SUBJECT: Change of motor relay on PEAL 401 power supply board code 5-108561(B)

In the ongoing process of product improvement, we inform you that, as of May 2023, we have made a change to the PEAL 401 power supply board, spare part code 5-108561(B), present in the Teco 680, Teco 680 plus, Teco 680 plus Touchscreen (with manual or automatic clamping) wheel balancer models.

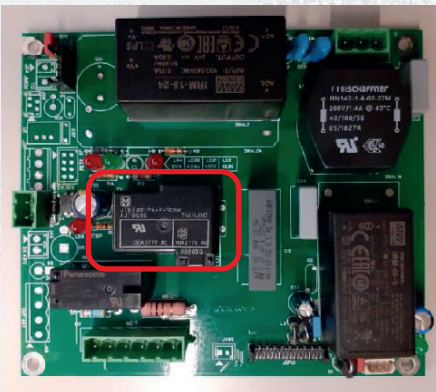
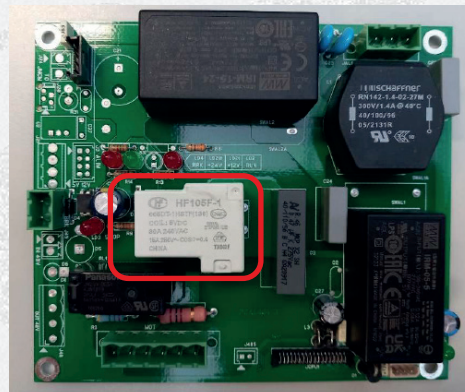
The change consists in the replacement of the electromechanical **RL2** relay with one of a different brand, model and colour, so as to avoid reported cases of failure to start the spin motor, resulting in the display of error message E30.

OLD VERSION 5-108561(A)

NEW VERSION 5-108561(B)
